Arboricultural Impact Assessment

100 St Georges Rd, Fitzroy North VIC 3068

Date of Report 16/06/2025

Report version B3.0

DRAWING TITLE:
Existing Conditions Plan

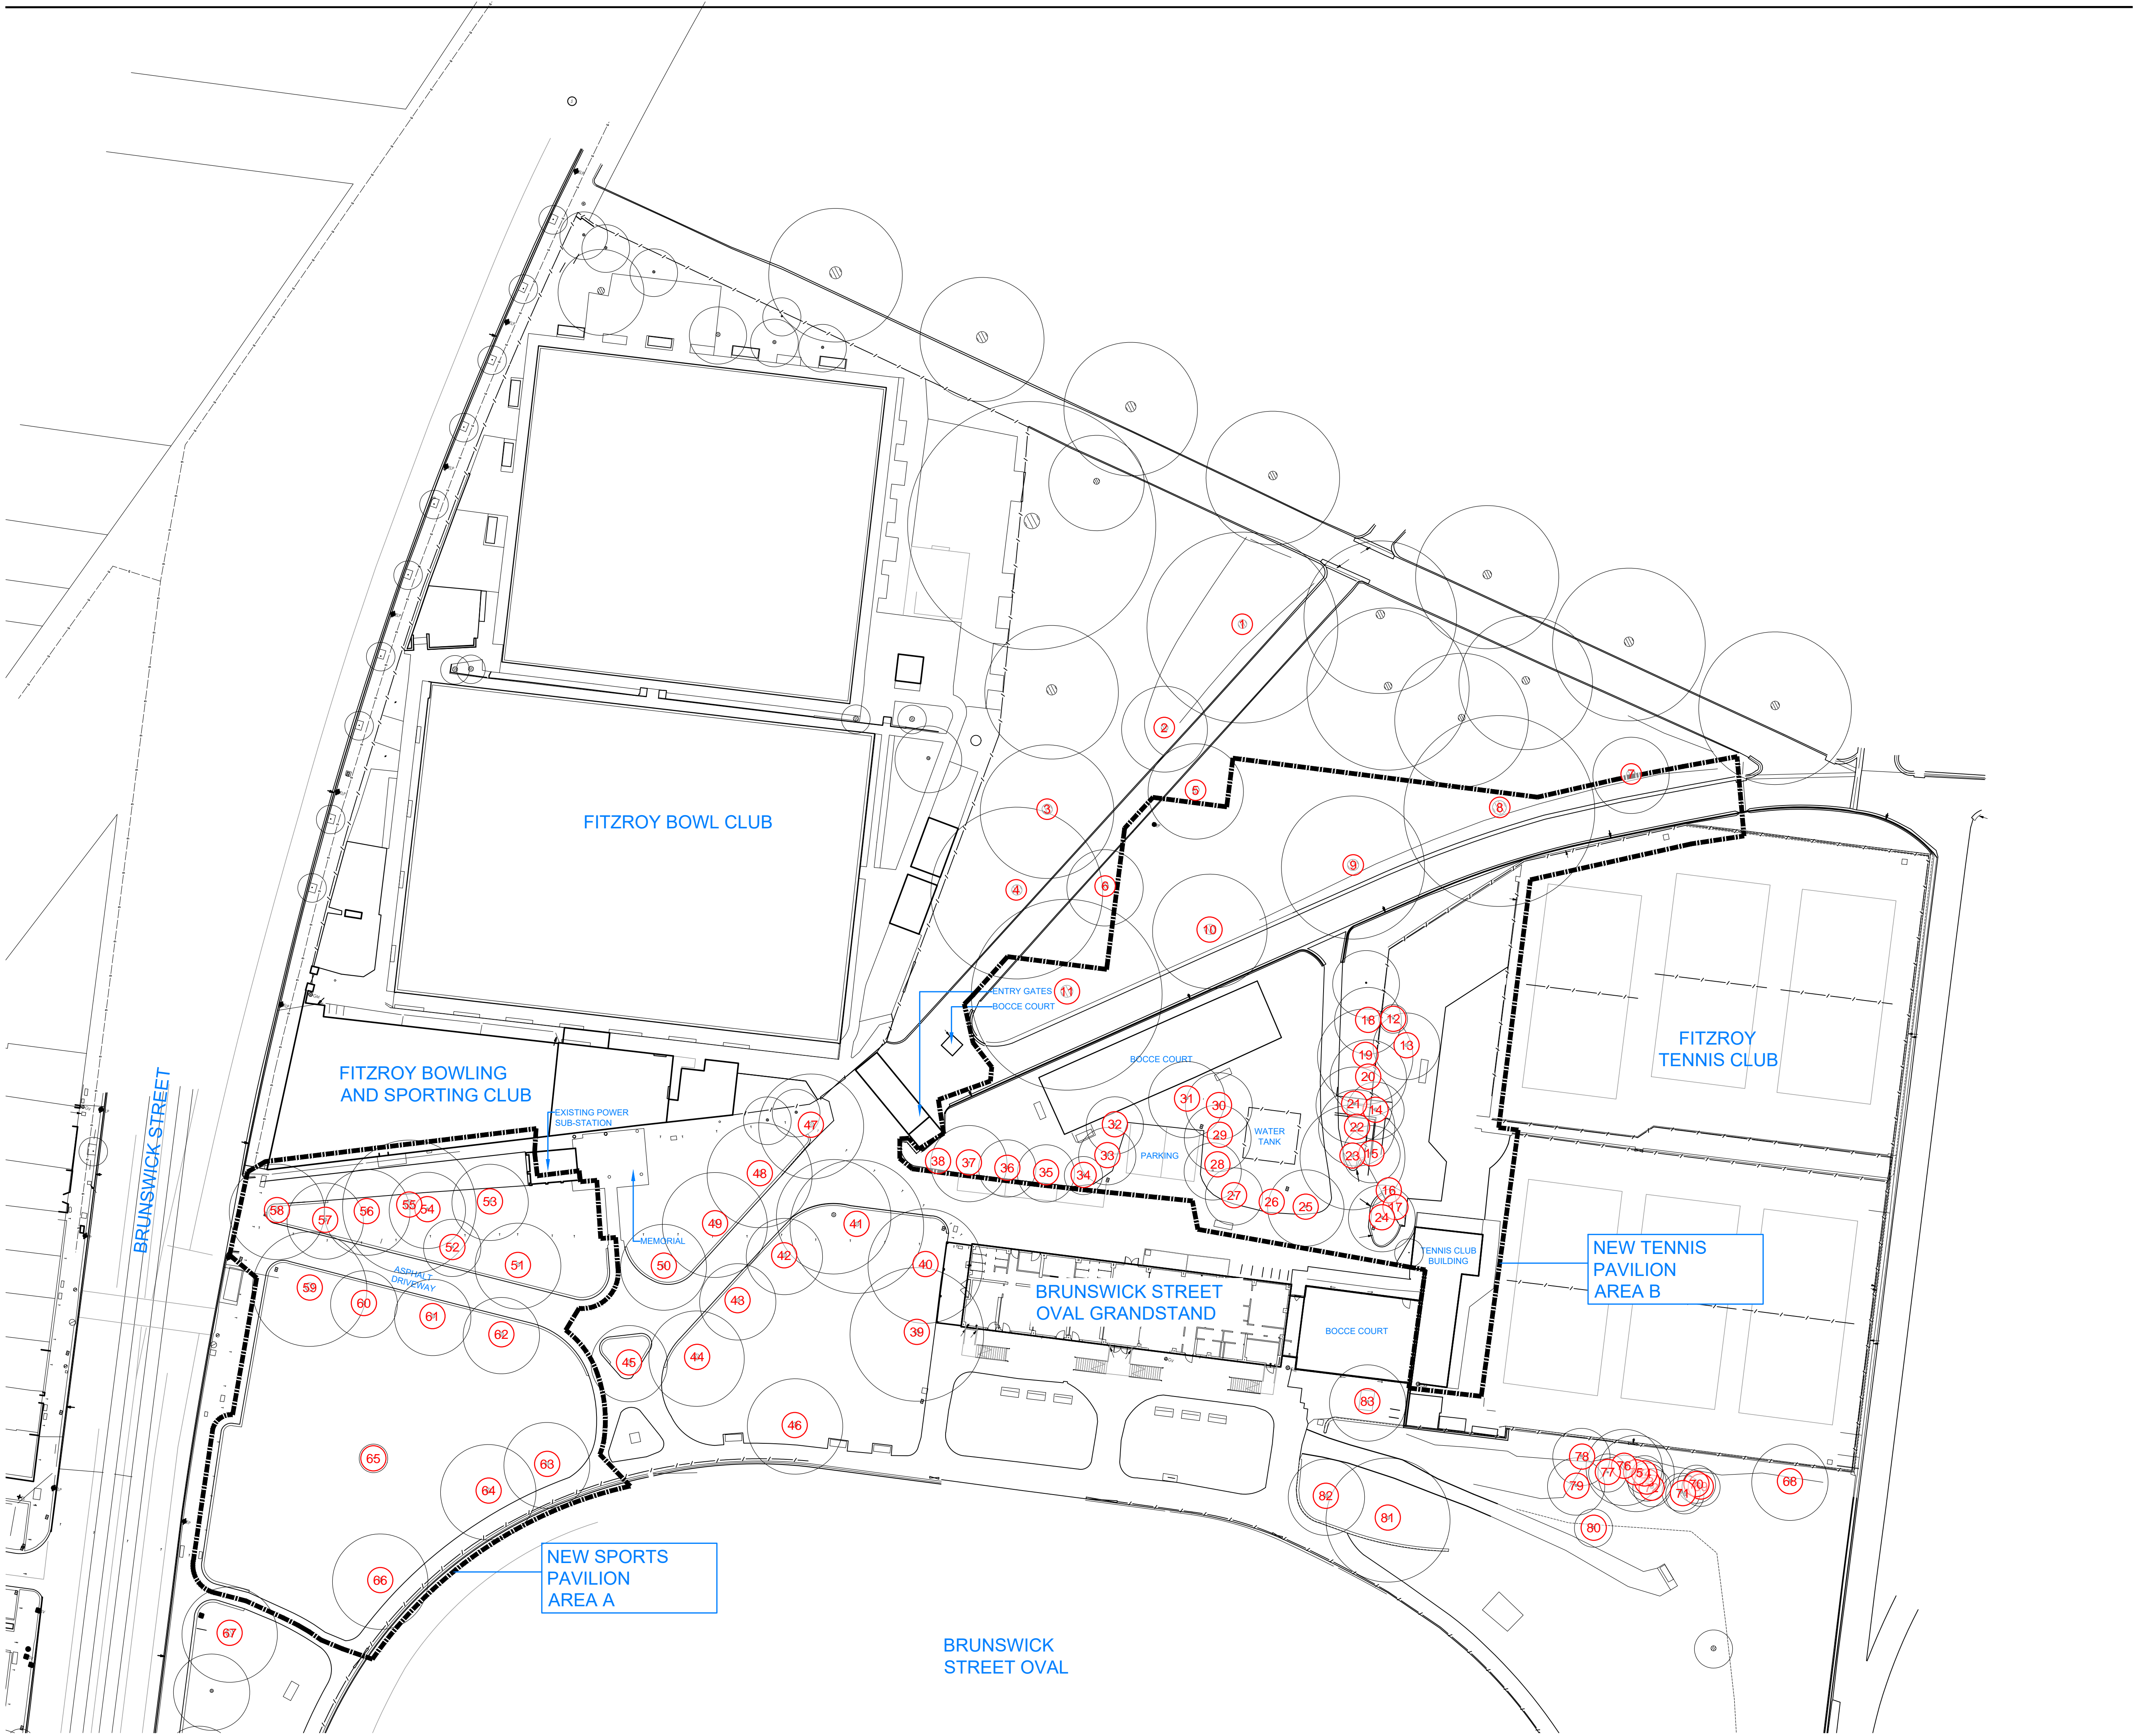
The tree is proposed to be retained, however, will not remain viable within the scope of the proposed development. Revision of the design to reduce the impact to a tolerable degree is required for retention of the tree.

Surface Finishes Plan-A

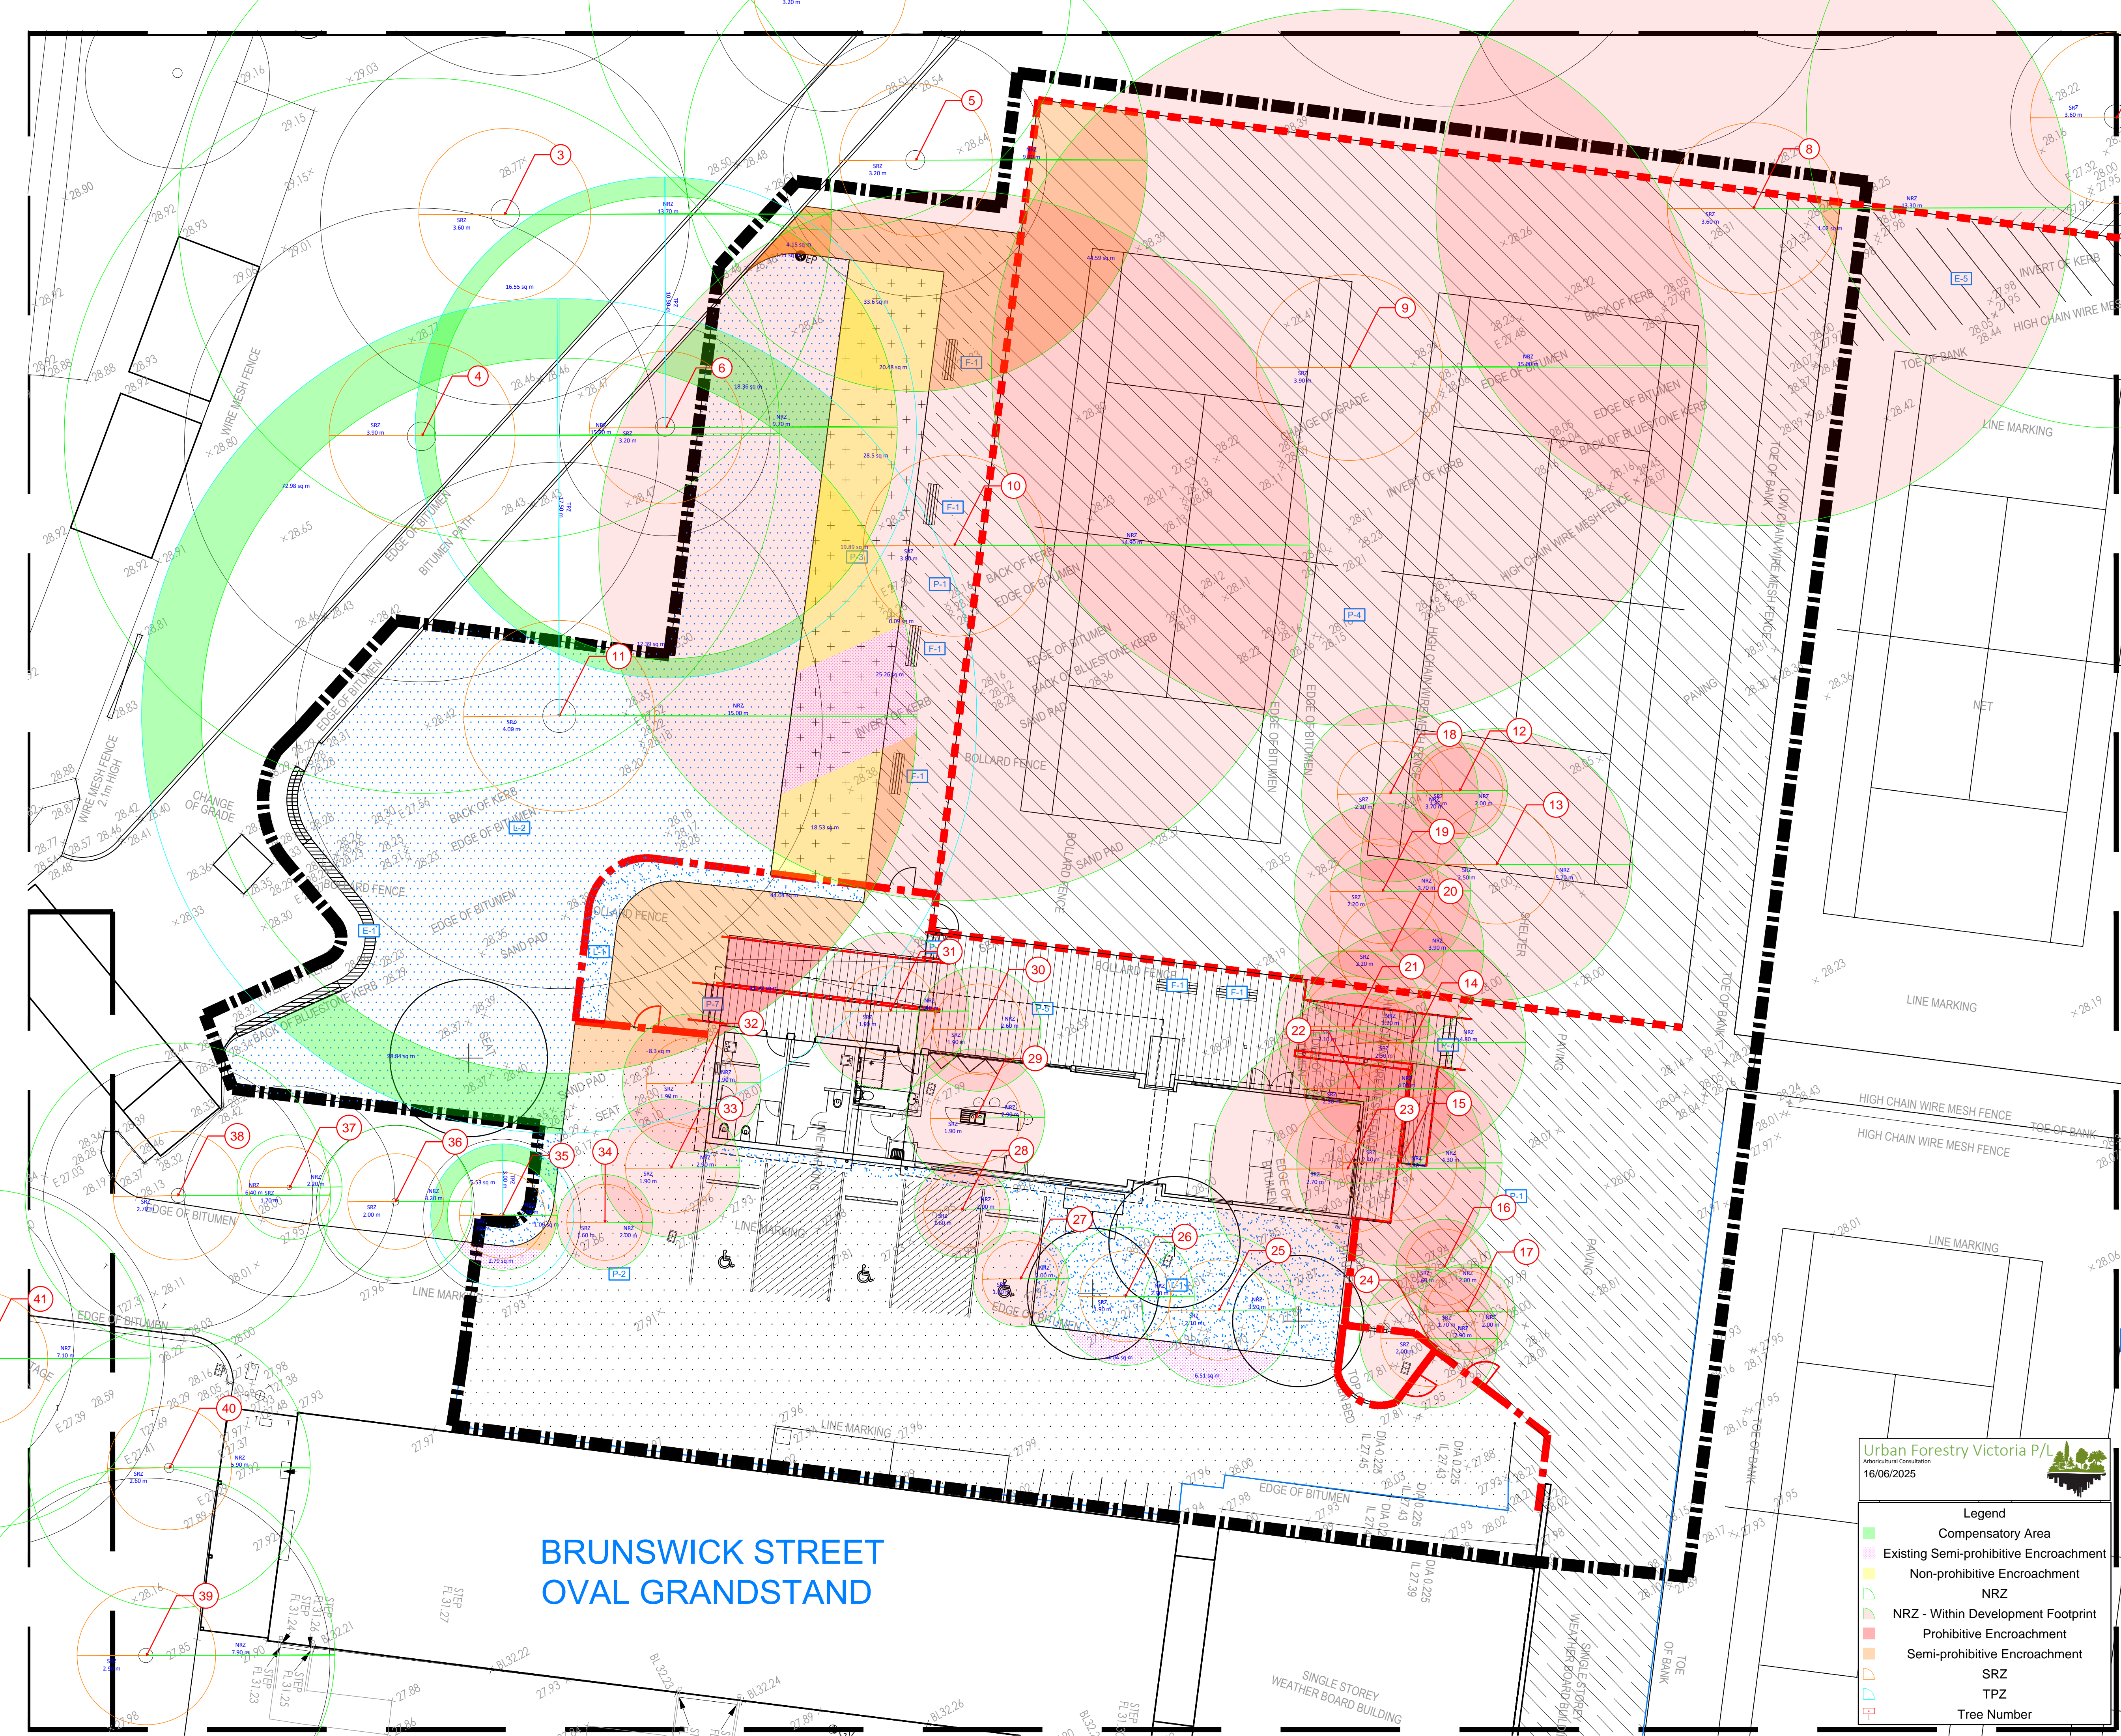
Within the context of the proposed design the NRZ will incur a 98.7m² (33%) encroachment from the proposed

- a) Clay tennis court surface, 44.59m² (15.0%) semi-prohibitive impact
- b) Concrete pavement, 33.60m² (11.3%) semi-prohibitive impact (SRZ impact)
- c) Granitic sand area, 20.48m² (6.9%) non-prohibitive impact

The type of NRZ area encroachment is major, in accordance with AS4970-2025.
